### **CORRIGENDUM**

**Tender No. IITM/SPS/CC/HPCE Cluster/008/2018-19**

**“Supply and Installation of HPCE Cluster“**

# ANNEXURE-E

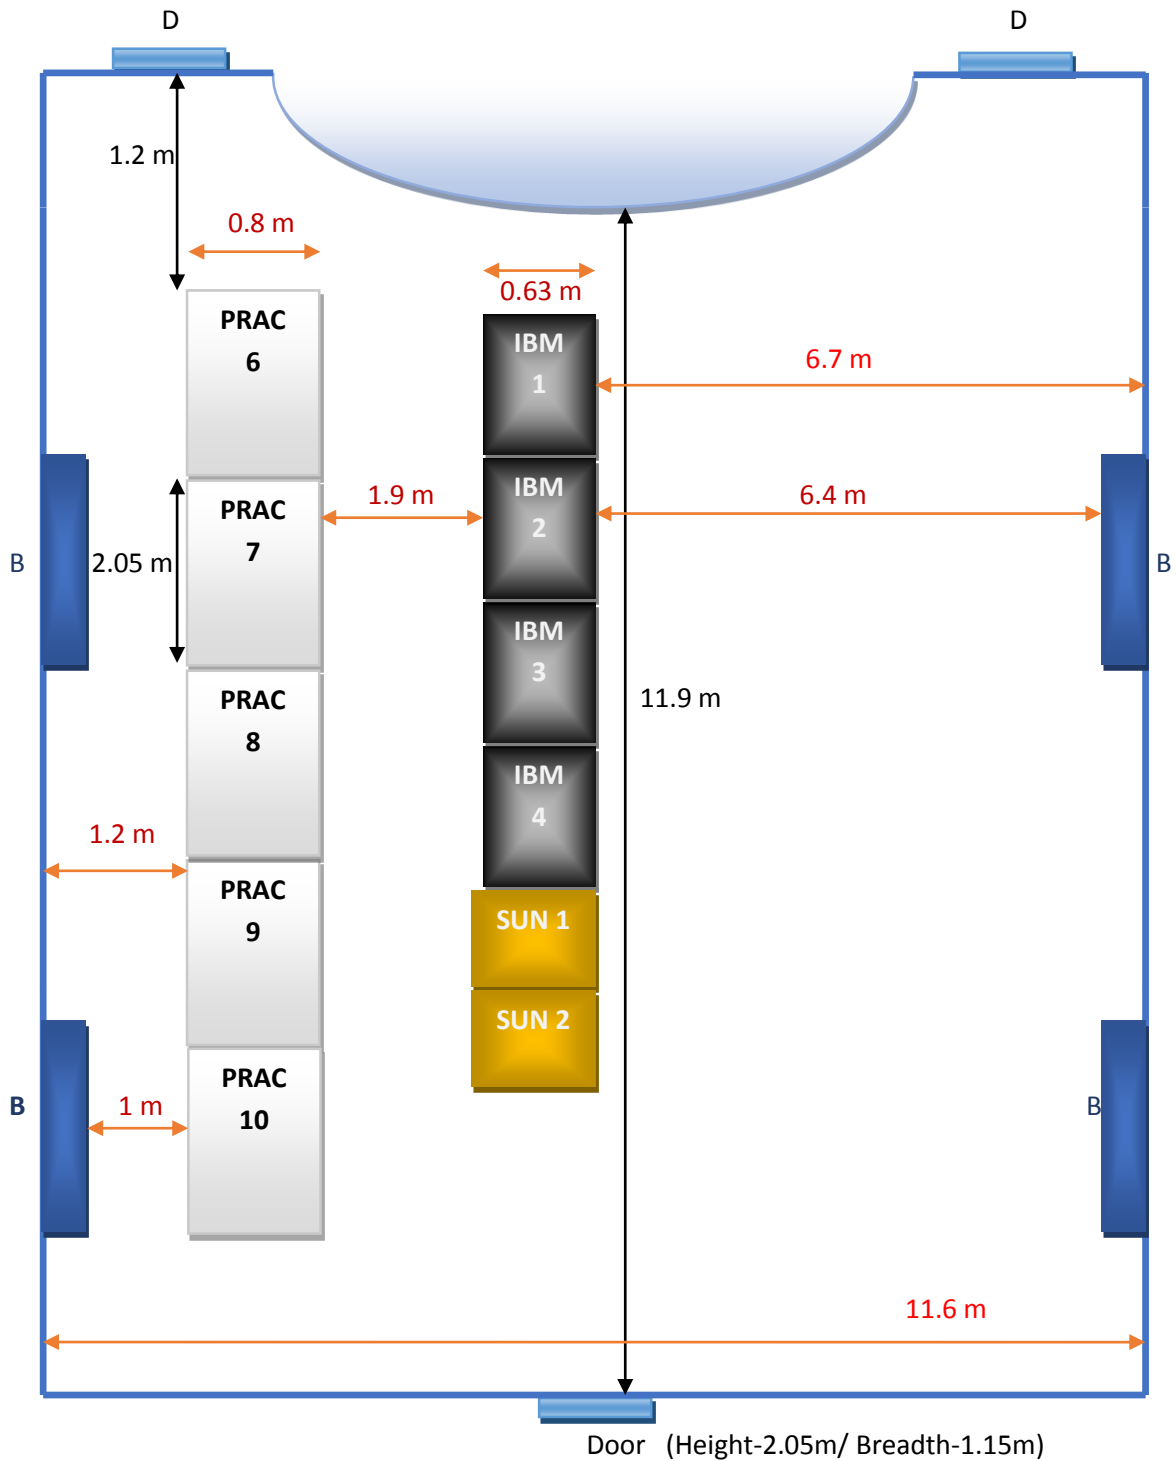
11) The space currently available should be utilized for the erection of the HPCE and we will not provide additional space for the installation of this new equipment which is proposed to be purchased. <b>Dimensions of Data Centre to host the solution provided by the vendor, height &amp; width of the doors and load bearing capacity is given in Annexure-E.</b>		
Instead of

i) The Annexure - E added newly.

- SERVER AREA dimension L X B X H – 11.9 m X 11.6 m X 2.75 m
- Available Area for New HPC Cluster – 11.9 m X 5.8 m X 2.75 m
- False floor depth – 0.6 m
- Load bearing capacity of floor tiles – 2200 kg.
